**CITY OF SAINT PAUL
HERITAGE PRESERVATION COMMISSION STAFF REPORT**

FILE NAME: 531 Dayton Avenue

CLASSIFICATION: Pre-Application Review

DATE OF REPORT: March 2, 2017

SITE & ROOF PLAN

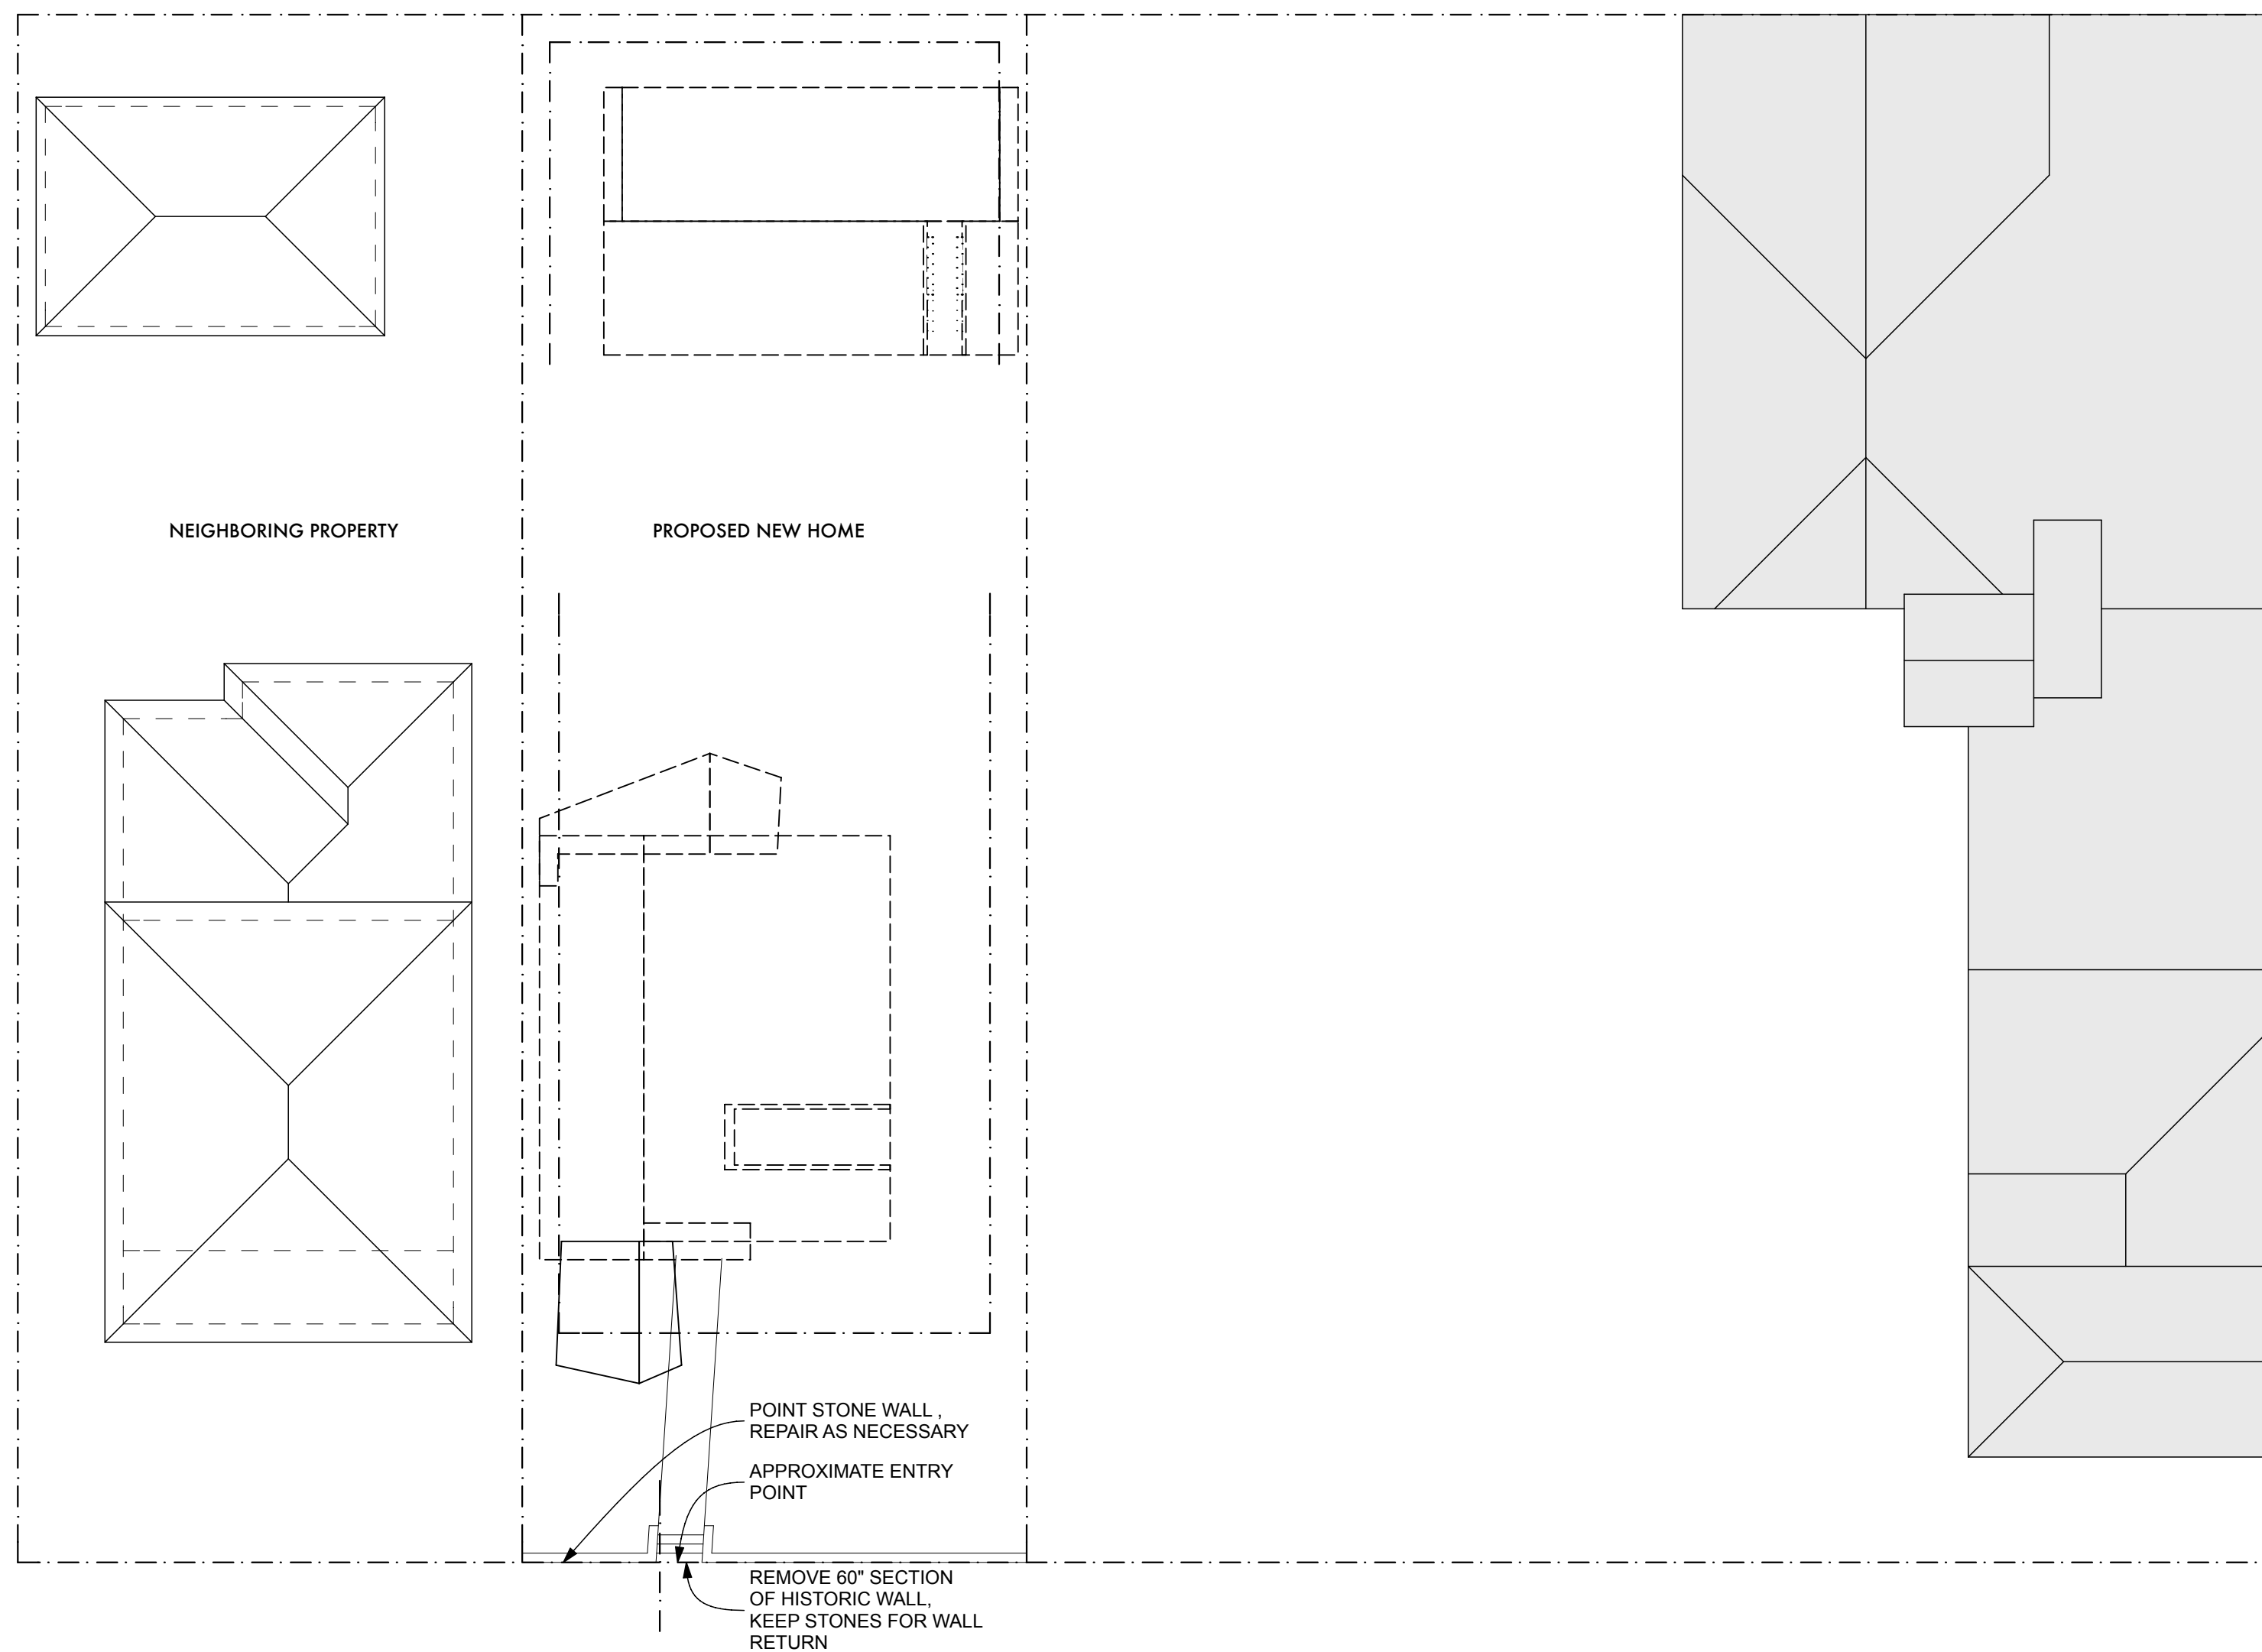
2. The lot is vacant, and the existing retaining wall along its south side should be maintained and utilized in the new site design. Damage to the wall in the course of adding a proposed stairway should be minimized and repaired in-kind.

7. **Materials and Detail: Roof.** The proposed asphalt shingles are permissible for new construction so long as they are of a medium to dark brown or medium to dark grey. The alternative metal shingle material presented would not comply with the guidelines. More detail about the solar shingle material for the garage roof needs to be provided for evaluation.

8. **Building Elements: Roof.** The irregular, multi-planed roof form does not *relate to the predominant roof shape of existing adjacent buildings*, and should be redesigned to achieve compatibility. The 12:12 pitch for the building's western portion is similar to the historic homes' roof pitches in the area, while the flatter pitches are not. Multiple roof pitches are not generally

present on front façades in the district except for porch roofs. Though not all details were shown on the plan, the guideline states *skylights, vents, and metal pipe chimneys should not be placed on the front roof plane* – those details, including finishes, will need to be shown on final plans.

12. Setback. The proposed front setback has not been provided. The building should be *sited at a distance not more than 5% out-of-line from the setback of existing adjacent buildings*. The block face's average setback is 24', and the neighboring property under construction was approved with a front setback of 26'.
